Group 13 Fuel System

Bulletin Number 13 03 90 (3039)

SUBJECT: Evaporative Purge Valve

MODELS: E30/E34 (with M20, 2.5L engine)

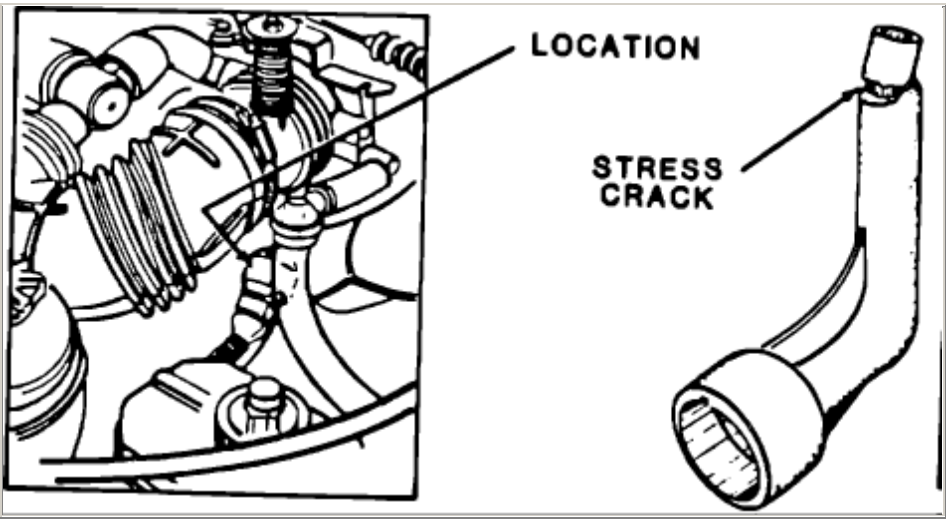
Situation: When the hose clamp is installed improperly, the molded hose connecting the purge valve to the intake manifold can crack.

The crack in the molded hose may be located on the small end near the intake manifold contact point. Visual inspection is difficult and the removal of the inlet air boot and/or other components may be required to view the molded hose properly.

Information: Replace any cracked purge valve molded hose with P/N 13 90 1 735 270.
